**Independent Advisory Panel to IDB Invest  
IAP Report N°5, March 2021  
Ituango Hydropower Project  
Colombia**

*Dam Engineering and Safety (Chair)*

Figure 2: Matrix of Project's Technical Risks in February 2021

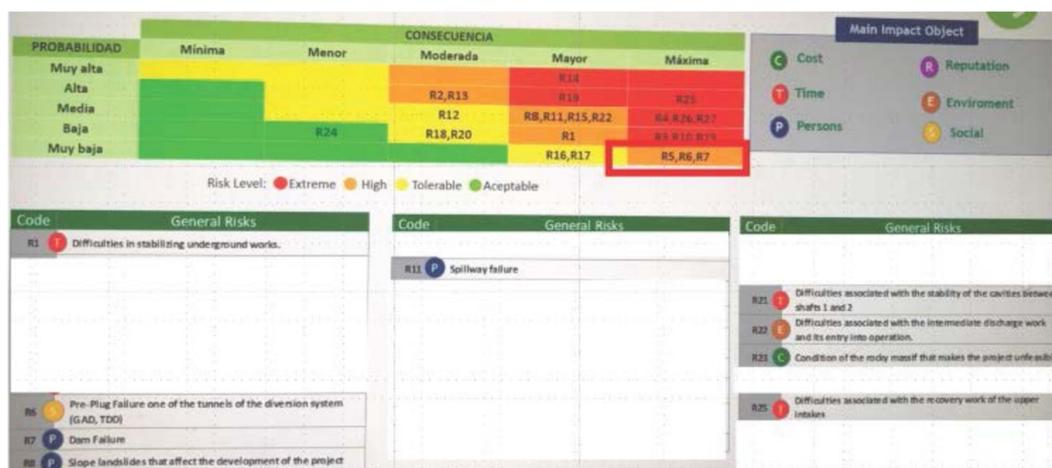
The IAP agrees, in principle, with the risk assessment of the different events, except in the case of R5 (GAD and TD2 sealing). Its probability of occurrence cannot be of the same level as that of “Dam Failure” (R7). Until successful sealing is achieved, the probability of occurrence of R5 should be moved up to «Baja».

Figure 3: Solution for sealing the TD2

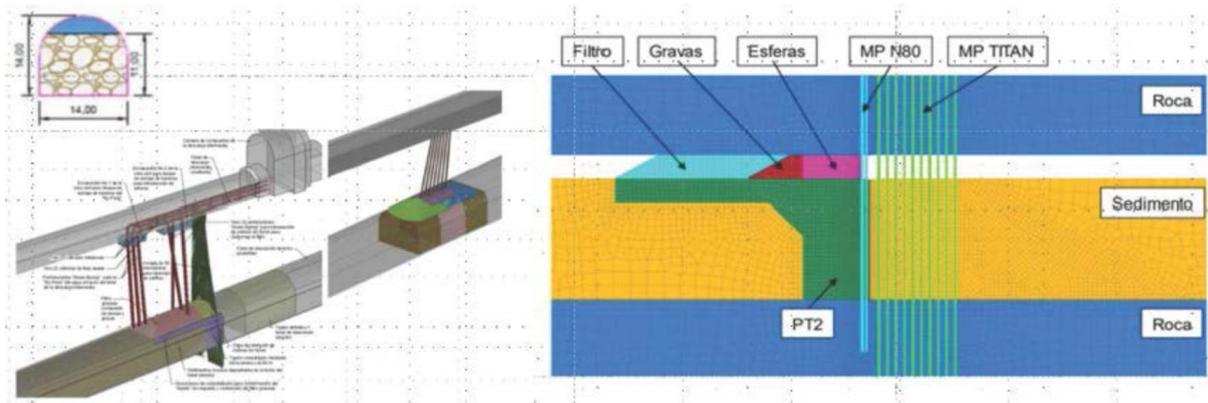
The IAP considers the designed solution feasible and suggests considering the use of wet foams in the process. The flow through TD2 is closely monitored during the sealing operations, in terms of head and velocity, which inform three levels of alert to protect the downstream areas. The IAP understands that a dedicated emergency preparedness plan (EPP) is in place for the TD2 sealing. The EPP should include a Response Level Matrix (RLM), which is standard practice the manage dam safety. Fig. 4 shows a typical RLM for a dam.

The alert levels, associated with the monitoring system, should be consolidated in a dedicated RLM.

*Figure 7: Turbines Hill Chart with guaranteed operating range and cavitation limits*

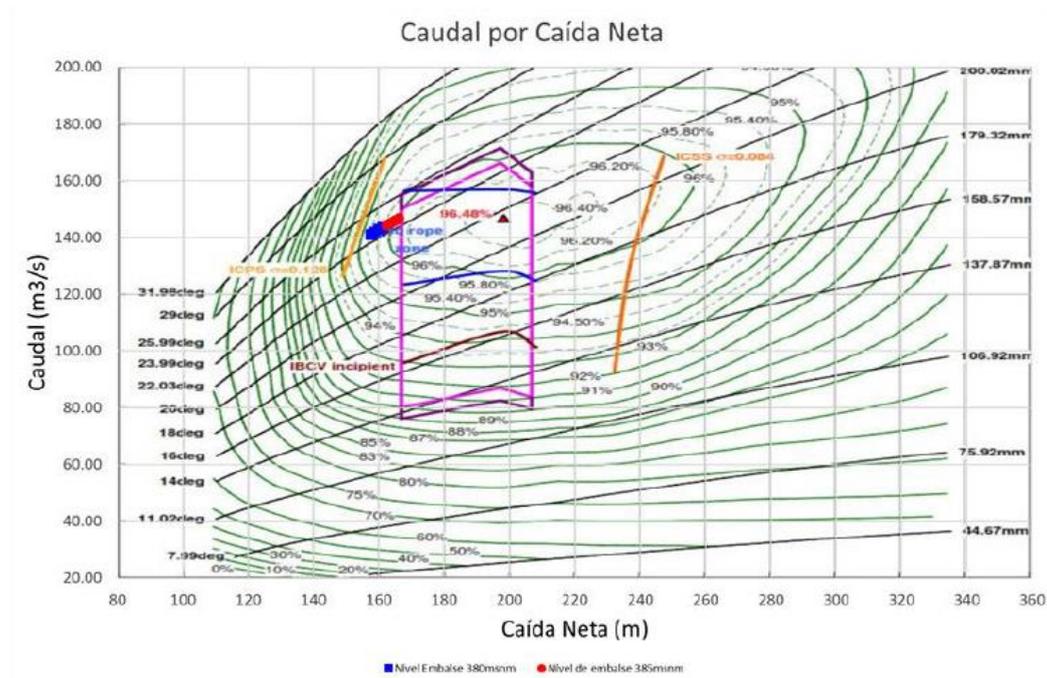
Both cavitation and vibrations increase gradually and may reach damaging effects either if the unit is operated for a long period outside the design limits, or if operated in a H-Q area too far from the limits.

The extension of operating range for elevation at 385 and 380 are shown respectively in red and blue. The orange line on the left shows incipient cavitation limit for the pressurize upper part of the runner.

Should the units need to be operated outside the design limits, in emergency conditions, monitoring vibrations should be an obvious requirement to be specified in the Project's Emergency Preparedness Plan.

Figure 13: Conceptual model of the Disturbed Rock Mass

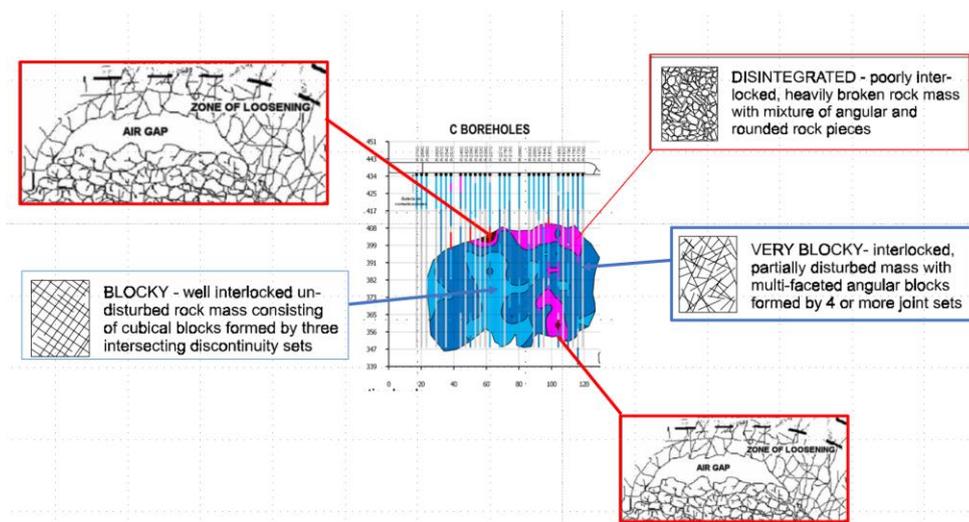
The postulated failure mechanism has implications on the nature of the DRM. It is expected that large voids exist in the upper part and in the lower part of the DRM. Such voids are not expected to extend to the rest of the DRM, which should feature various degrees of disturbance, from disintegrated in the vicinity of the voids, to blocky and very blocky, with discontinuities of variable openings: more open in the vicinity of the borders, closer in the inner, vaster, part of the volume. Fig. 13 illustrated a conceptual model of the DRM based on the above considerations.

The IAP agrees that grouting is the appropriate solution for treating the DRM, with different technologies:

Techniques a) and b) should be appropriate for the «boundary disturbances» i.e., large voids and disintegrated rock. Technique c) should be appropriate for the DRM's core.

Permeation grouting should be carried out radially, from inside the shaft conduits while they are rehabilitated. Given the inevitable uncertainties associated with the volume of the DRM, the IAP recommends adopting systematic grouting patterns.

*Fig 15: Geophysical investigations planned to assess quality of the grouting works*

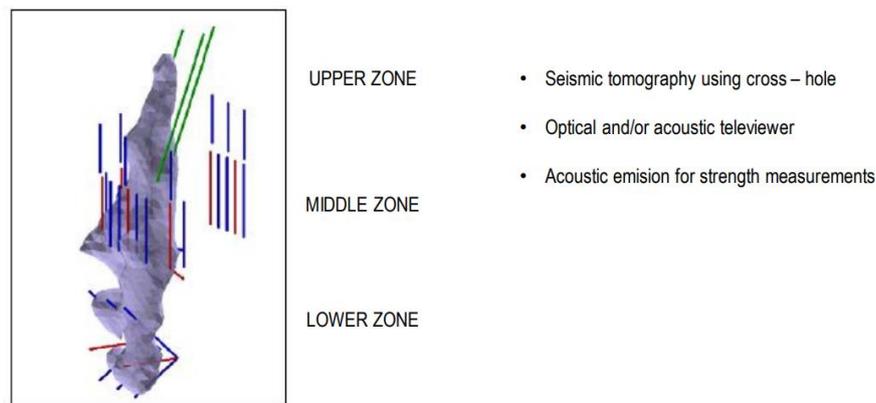
To check grouting's effectiveness, a series of geophysical investigations are planned (figure 15). IAP concurs noting that inclined boreholes will also be used. Drilling core will be collected, and water pressure tests performed.

Figure 21: Foundation piezometers

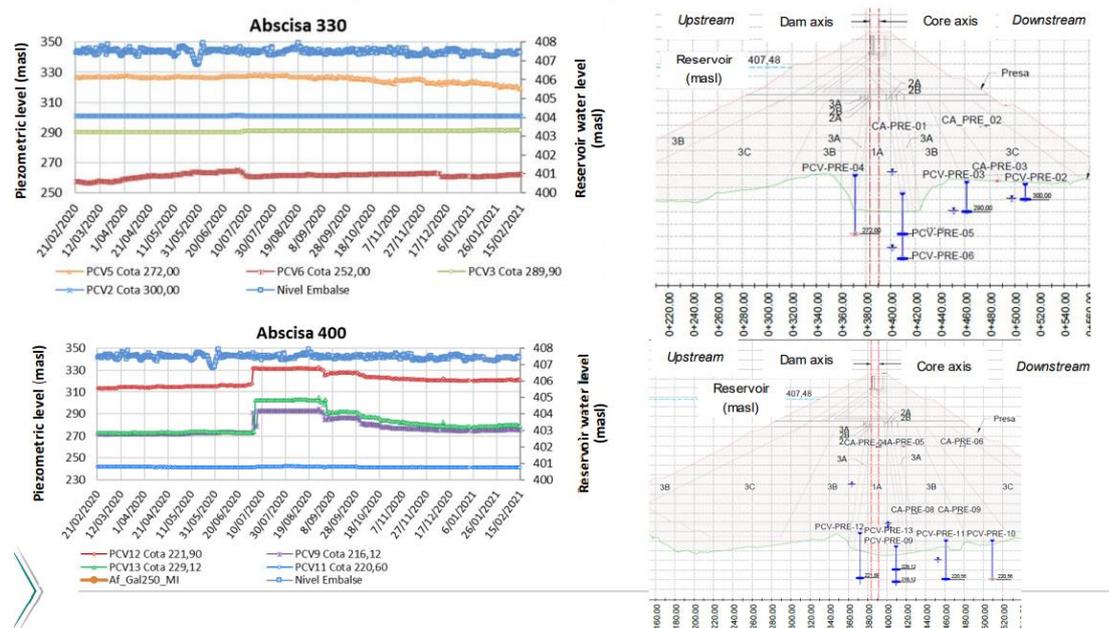
Foundation piezometers indicate a good performance of the grout curtain, with low elevations of the piezometric line. Variations in the readings of some piezometers at chainage 400 have been attributed to the grouting performed from gallery at el. 250 towards the deep curtain. In the section at ch. 330, two piezometers show levels that would imply a flow in the upstream direction (fig. 21). Since this cannot be real, a check should be done.

Figure 36: Left side of the reservoir. Area of questionable stability, 0+900 – 1+300

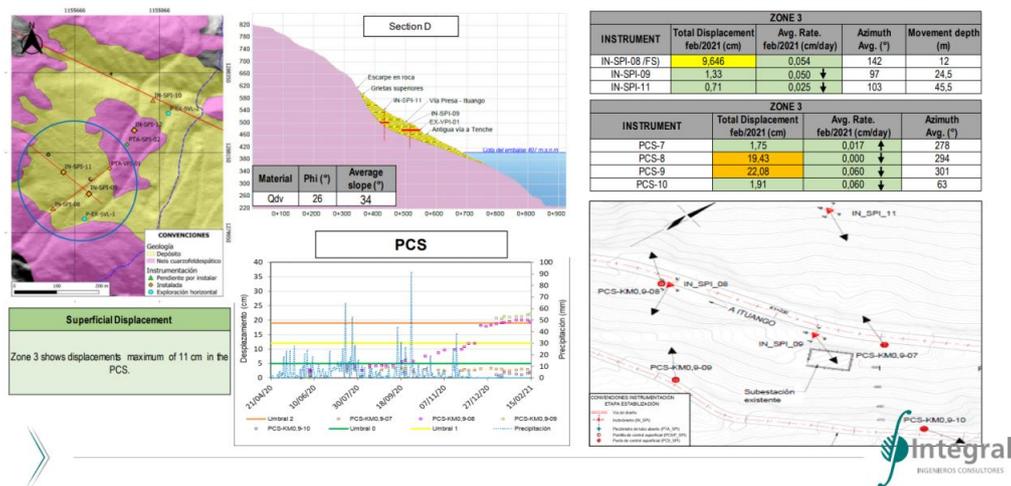
Site investigation is ongoing between km. 900 and 1+300 of the diversion road on the left side of the reservoir. The beds of the gneissic schist dip into the slope in its high parts, which is a favorable element. At the same time, the morphology of the area indicates a potential for rotational slope failure. The three inclinometers, although relatively close to each other, show big differences of the sliding surface depth: 12 - 24.5 - 45.5m respectively. The few piezometers are reported not to have encountered ground water (fig. 36).

IAP believes that additional instrumentation should be installed, and a parametric stability analysis performed using reasonable soil properties. Surface signs of ruptures/ tension cracks should be mapped.

Figure 63: Annual and Cumulated Investment Costs

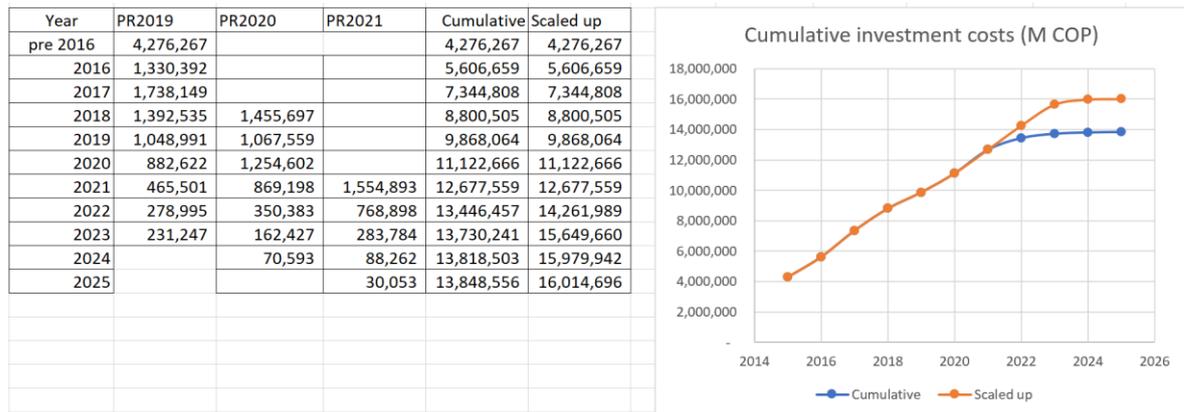
Observing the plot of the cumulative investment costs, one notes that the curve is practically flat after the year 2022 (blue line). The IAP disagree with that because:
